Panoramic Glass Roof has a Pop Noise

AFFECTED VEHICLES

Year	Model	Trim	VIN Range
2019–23	RDX	ALL	ALL
2022–23	MDX	ALL	ALL

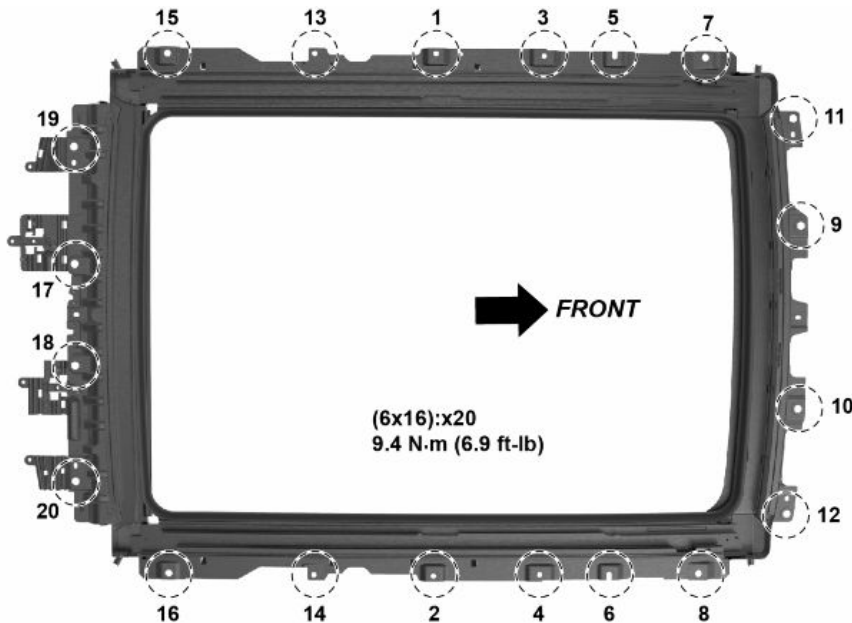
NOTE: Follow the Service Information procedure; search keyword **Panoramic Glass Roof** > select **Panoramic Glass Roof Mechanical Component Location Index** > select **FRAME: Removal and Installation**. After replacing the frame assembly, follow the torque pattern below. Make sure each bolt is torqued to specification **9.4 N·m (6.9 ft-lb)** during the installation process.
